Subject: Inspection of the airbrake stops

Concerning:	Model/Series	S/N's
	ASTIR CS	1001 - 1536
	ASTIR CS 77	1601 - 1844
	ASTIR CS Jeans	2001 - 2248
	Club Astir II	5001 - 5061 (suffix "C")
	Standard Astir II	5001 - 5061 (suffix "S")
	G 102 Club Astir III	as of 5501 (suffix "C")
	G 102 Club Astir IIIb	as of 5501 (suffix "Cb")
	G 102 Standard Astir III	as of 5502 (suffix "S")
	SPEED ASTIR II	4001 - 4027
	SPEED ASTIR IIB	4028 - 4107
	TWIN ASTIR	3000 - 3291
	TWIN ASTIR TRAINER	3088 - 3291 (suffix "T")
	G 103 TWIN II	3501 - 3729
		3730 - 3878
		33879 - 34078
	G 103A TWIN II ACRO	3544 - 34078 (suffix "K")
	G 109	6001 - 6159
	G 109B	as of 6200

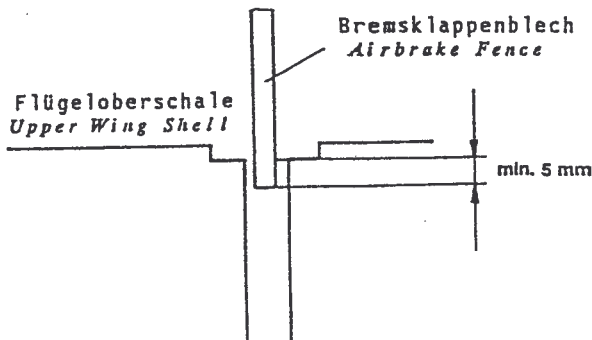
1. Inspection of the airbrake stops
As a precautionary action, the airbrake stops (outboard edge of the airbrake boxes) must be inspected for condition and wear. Cracks in the gelcoat around the outboard end of the airbrake box may indicate damage to the GRP laminate underneath. With the airbrakes fully extended wear to the airbrake stops must be checked; assure that the outer airbrake swivel levers are in contact with the stops during this check: The lower edge of the airbrake fence must overlap the bottom of the airbrake cap recess in the upper wing shell by 5 mm min. (see drawing below) Normal wear is acceptable as long as the upper condition is fulfilled.

- Airbrake Stops
Airbrake Fence/Airbrake Box Overlap 5 mm min.
